***An Evaluation of Wastewater Disposal
via
Discharge to Groundwater
at Block 23, Lot 1,
Borough of Hampton,
Hunterdon County, New Jersey***

***Prepared by:
Raymond A. Ferrara, Ph.D.***

January 5, 2012

**FIGURE 4
Proposed Disposal Area**

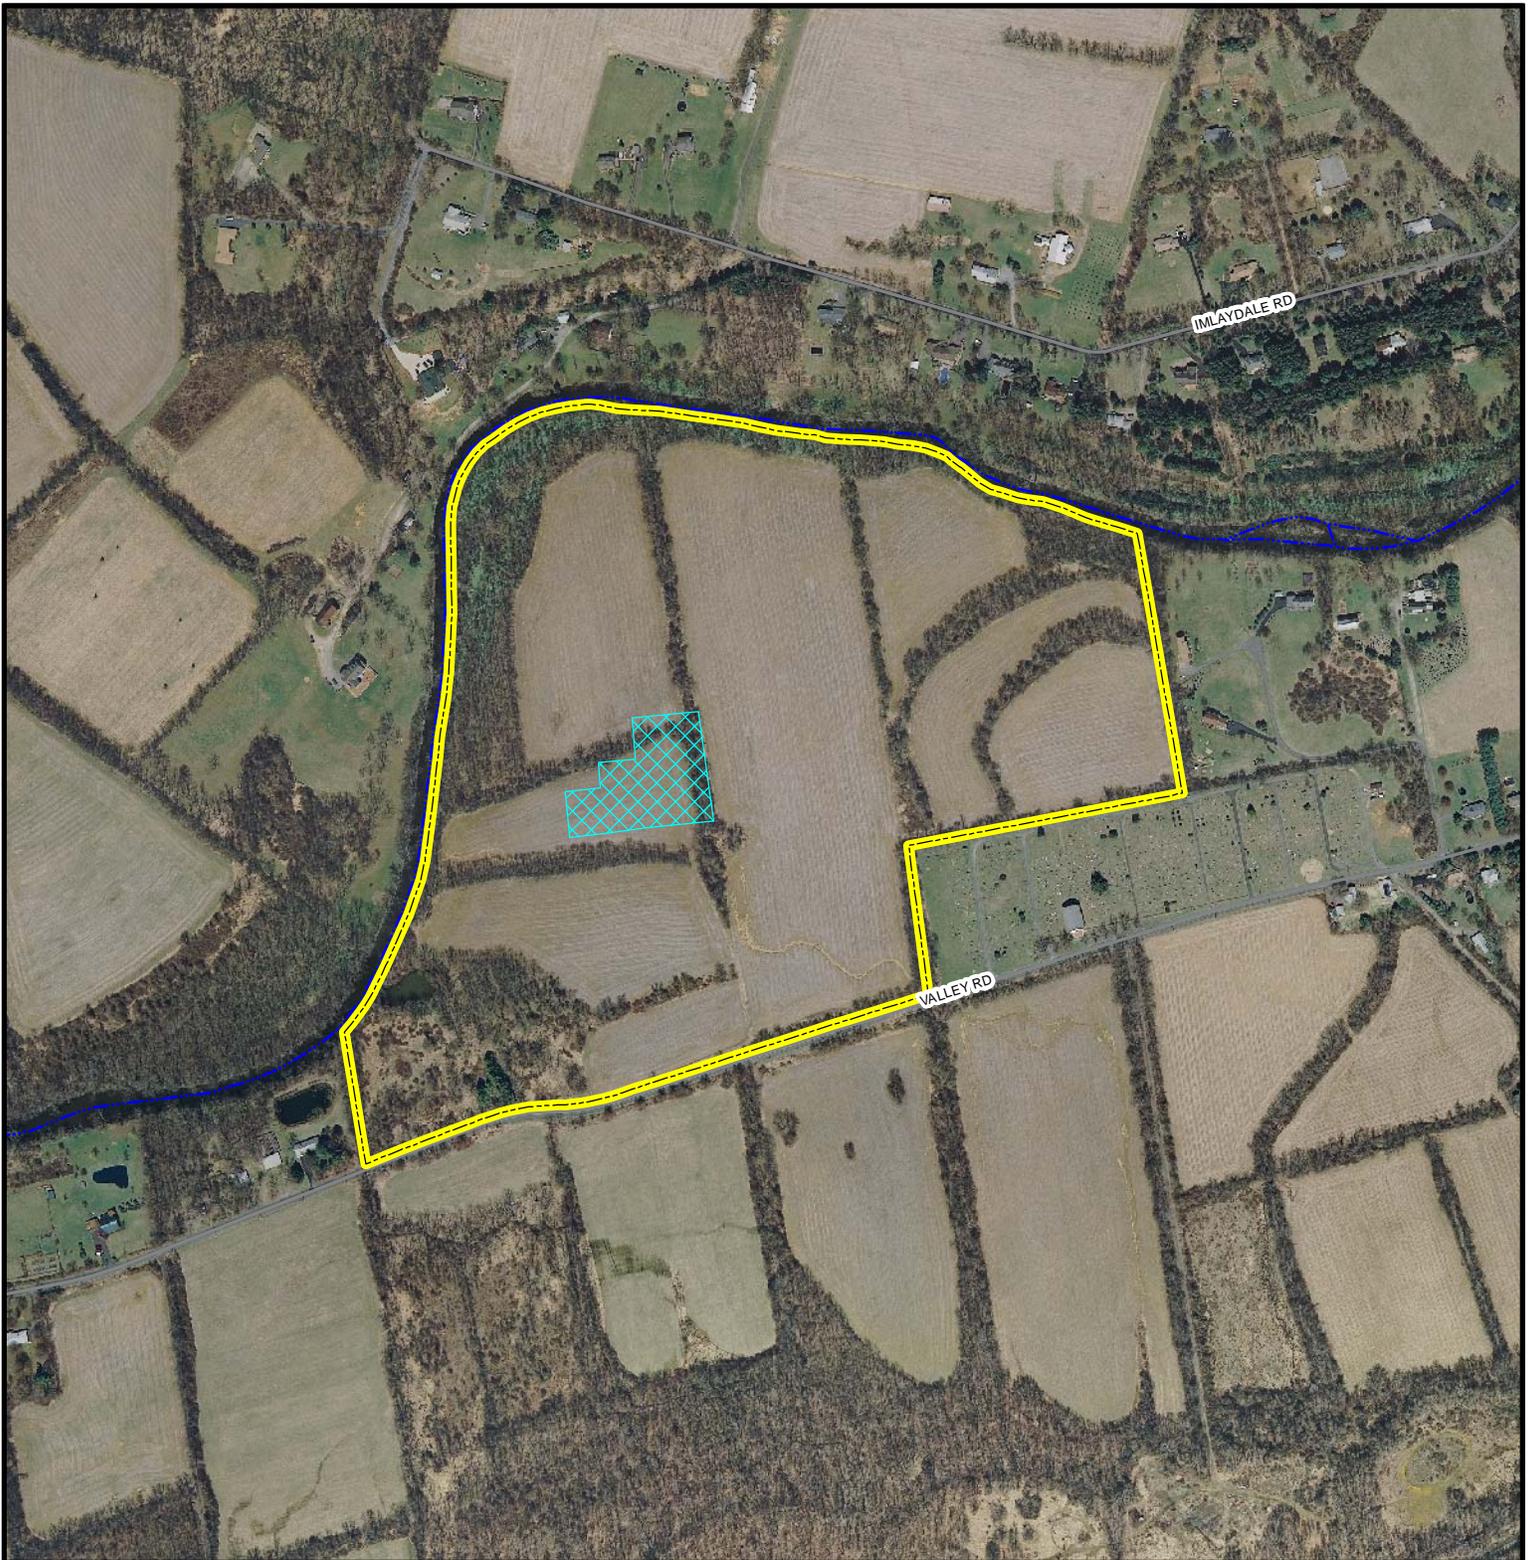
AWM January 2011 found that the location proposed for discharge to groundwater in AWM August 2010 was not suitable. Poor conditions for discharge to

groundwater “were present across most of the site”. AWM indicated that an area in the west-central portion of the site should now be considered for the wastewater disposal field. That area is depicted in Figure 4. New mounding calculations were not performed at this location. Instead, the preliminary mounding calculations conducted at the prior location were assumed valid for the new location. AWM indicated that further site specific testing is needed. AWM also indicated that groundwater seepage was observed at 12 to 14 feet below grade in two test pits near the newly proposed disposal area (i.e., AWM test pit locations SL121610-2 and SL121610-3 as will be subsequently illustrated in Figure 10). AWM indicated that this seepage “is not necessarily coincident with seasonal high water level conditions”. But the occurrence of that seepage apparently caused AWM to avoid locating the new disposal area near these test pits. AWM also indicated that “wet season static water level measurements are crucial”. A footnote in Figure 1 of AWM January 2011 indicates that the choice of the new location did not take into account “measured seasonal high water, regional hydrogeology, nor contaminant transport.”

**FIGURE 10
Topography**

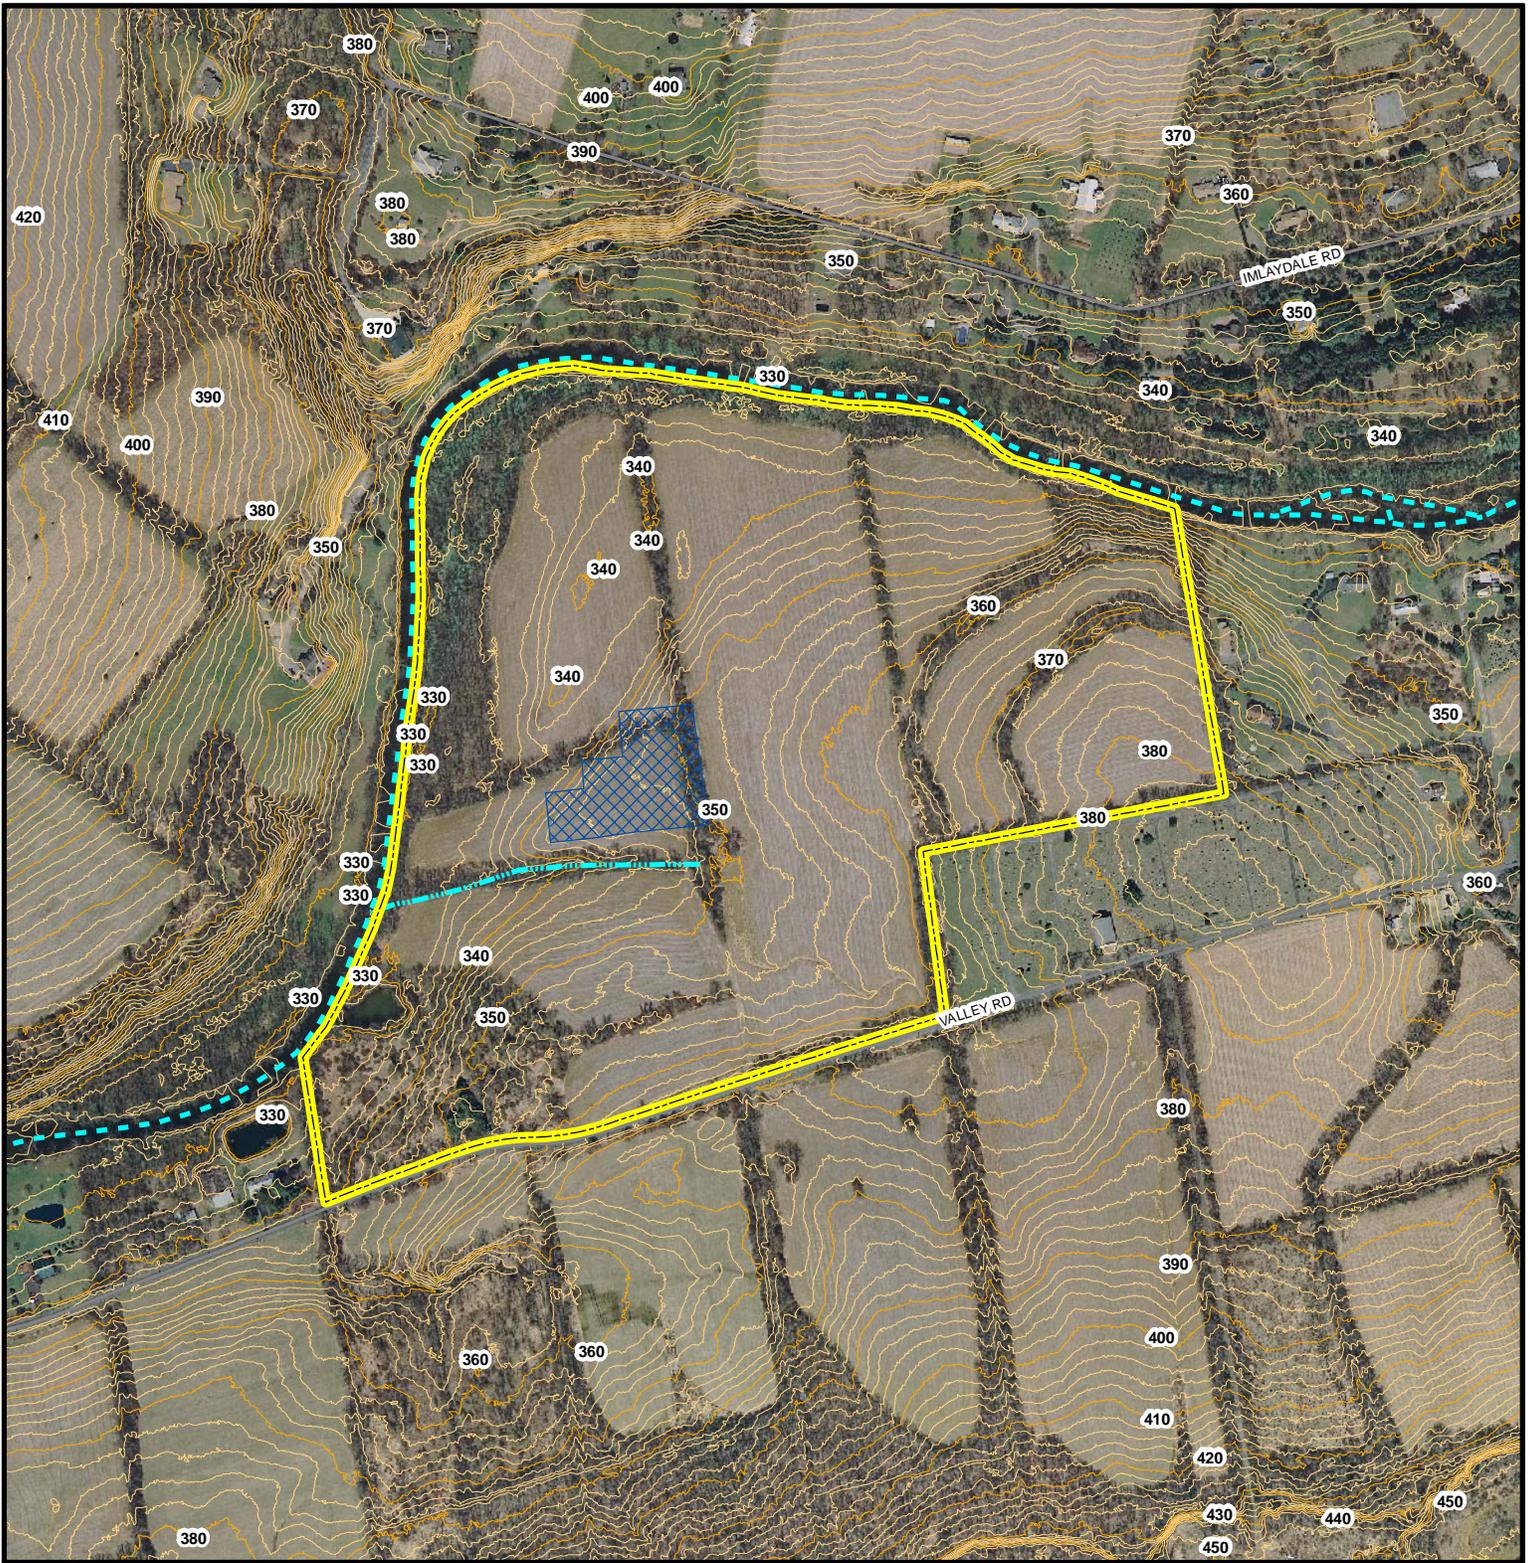
Figure 10 shows land surface contours for the subject property. Note the good agreement between the contours and the tributary that flows from east to west just south of the disposal field (as previously shown in Figure 6). The tributary may actually extend

further to the southeast as evidenced by the contour lines and aerial photo. Also note that the approximate elevation of the water surface elevation of the Musconetcong River (i.e., approximately elevation 328 feet in the vicinity of the proposed discharge to groundwater) is consistent with groundwater elevations in the borings presented in AWM July 2011 supporting the conclusion that there is a direct link between groundwater and the River.

FIGURE 11
AWM Soil Borings
& Test Pits

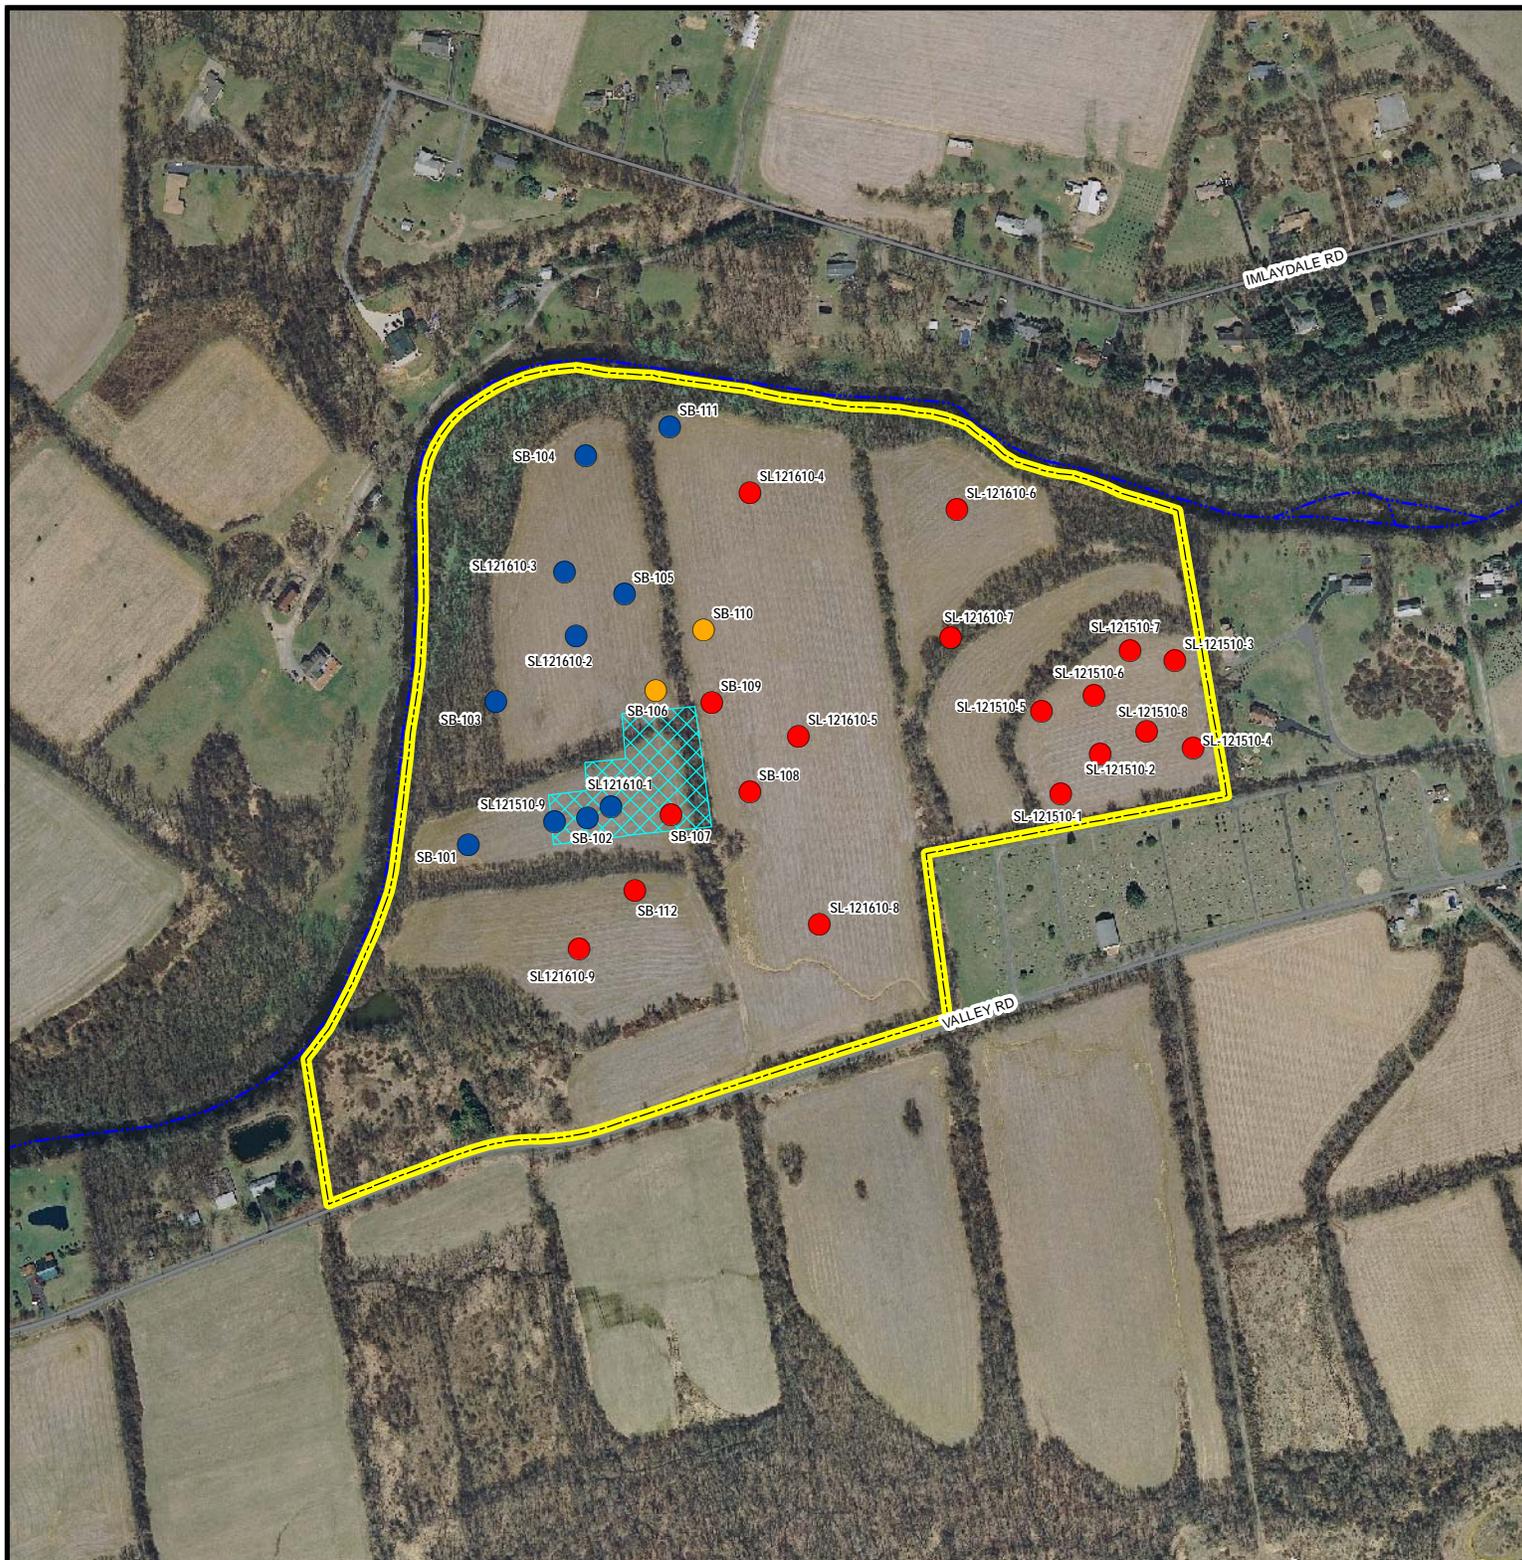
7. Figure 11 illustrates all of the test pits and soil borings presented in the AWM reports along with the second area proposed for wastewater disposal via discharge to groundwater. Clearly one soil boring (SB-107) deemed not suitable by AWM is within the disposal area.

FIGURE 12
Constraints to Discharge
to Groundwater

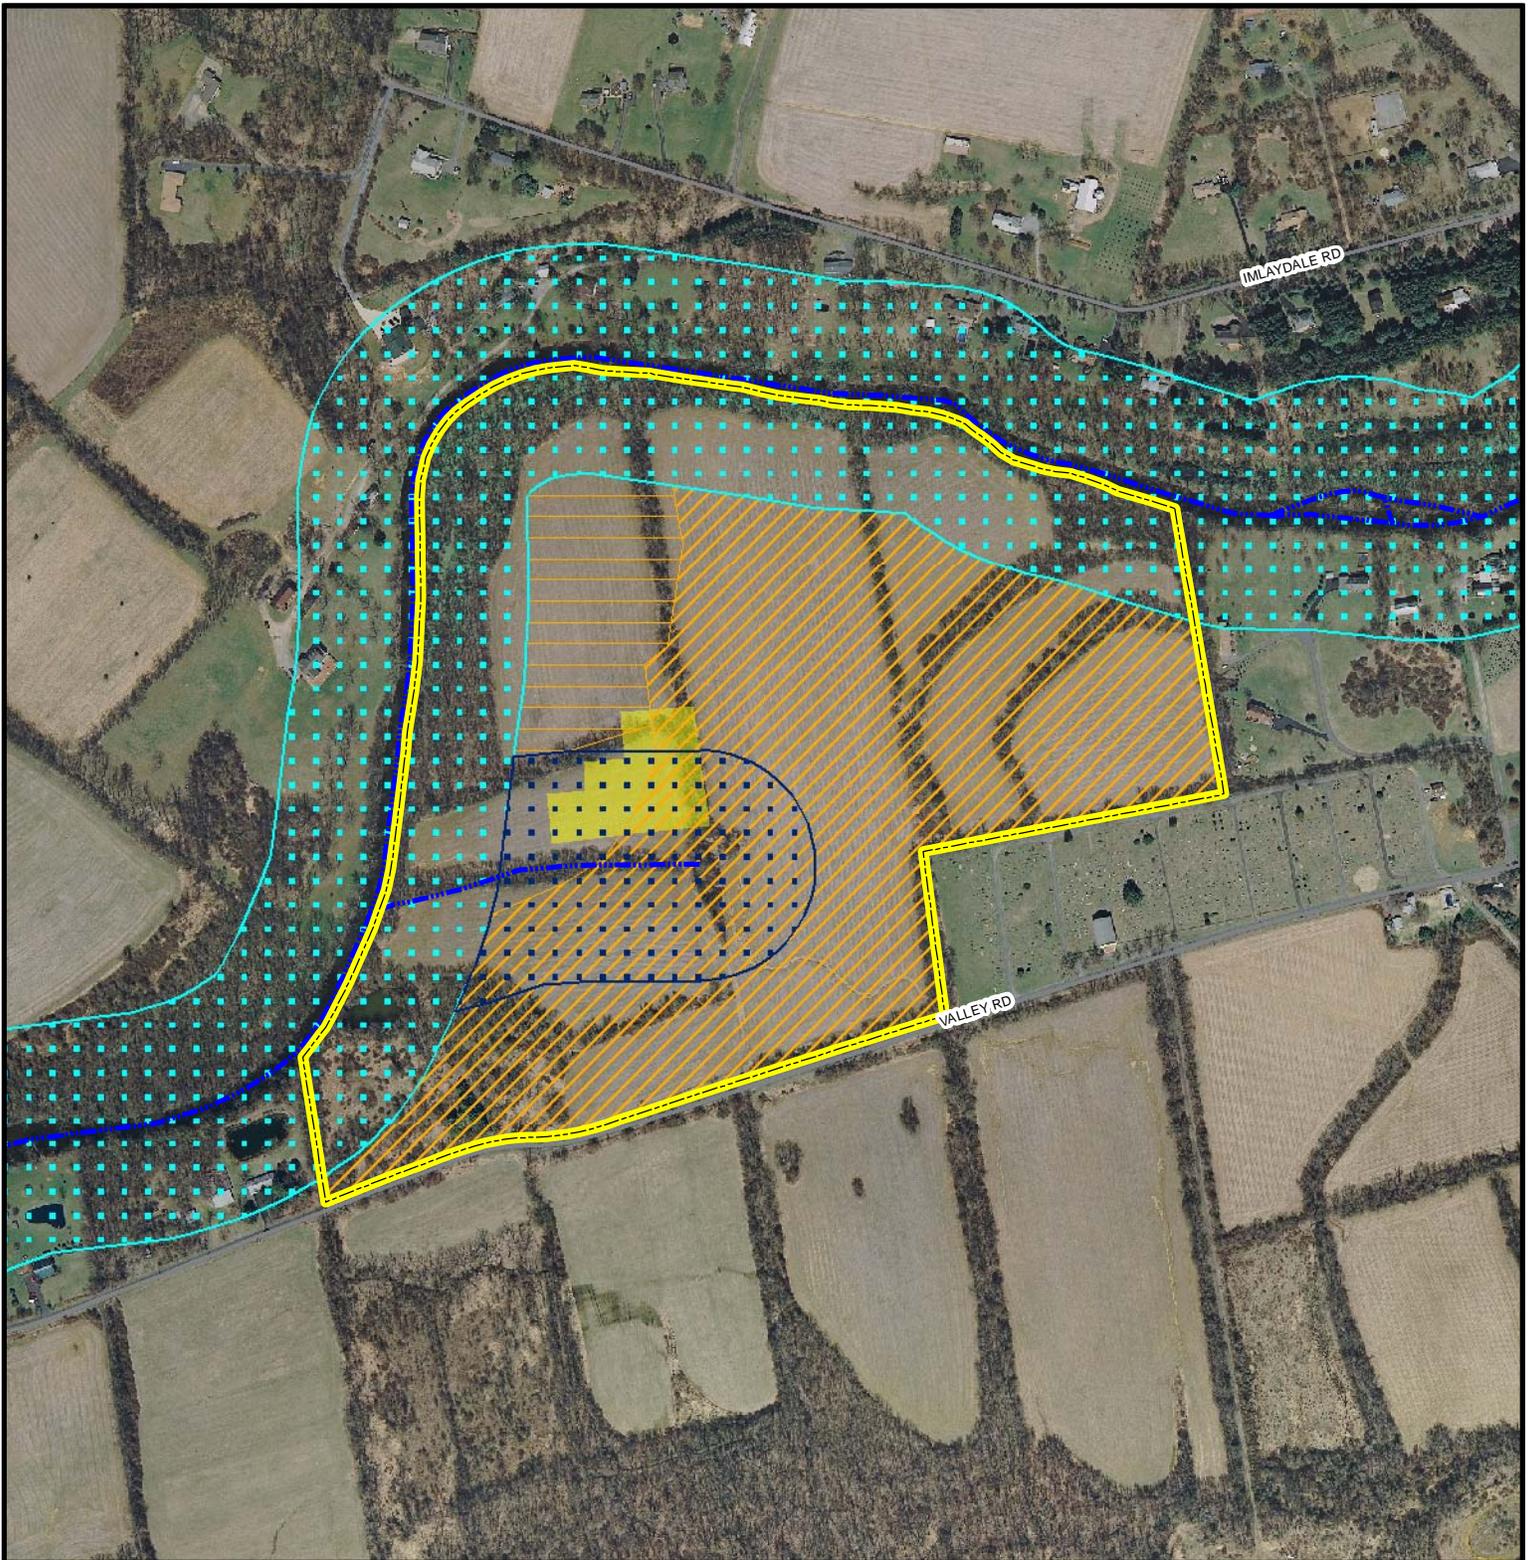
9. A number of environmental constraints limit the area potentially suitable for a discharge to groundwater facility. These are illustrated in Figure 12. The soil borings and test pits completed by AWM characterize most of the site as not suitable for such a facility. Other constraints such as the SWRPA 300 foot buffer further limit the suitable area. The Highlands Council riparian area and open water protection area (which are not depicted in Figure 11) place additional restrictions on the potentially available area. For the limited area that AWM characterized as having “suitable” soil data outside of the Musconetcong River SWRPA, the lower wooded area must be excluded since based on aerial photographs, topography and the Soil Survey maps, a surface water drainageway travels through it. In the northern area, soil boring SB-105 was indicated to have groundwater at less than 10 feet below ground level and test pit SL121610-2 was

noted to have groundwater seepage at 12 to 14 feet below ground level making that area questionable due to shallow groundwater. (Long term groundwater level monitoring was not conducted at either location, and neither test was particularly conducted during the time when the seasonal high water table might occur, so groundwater levels may be even shallower.) Based on the limited data available, a groundwater mound of approximately 13 feet would be prohibitive in this area. Therefore, even if one excludes the SWRPA for the tributary, the only potentially suitable area for a discharge to groundwater is a portion of the second disposal field proposed by AWM. And of course as shown in Figures 6 and 12 that area is located within the SWRPA for the tributary to the Musconetcong River. Furthermore as noted above, the direct connection of this area to the Musconetcong River places a severe restriction on its suitability for wastewater disposal via discharge to groundwater.
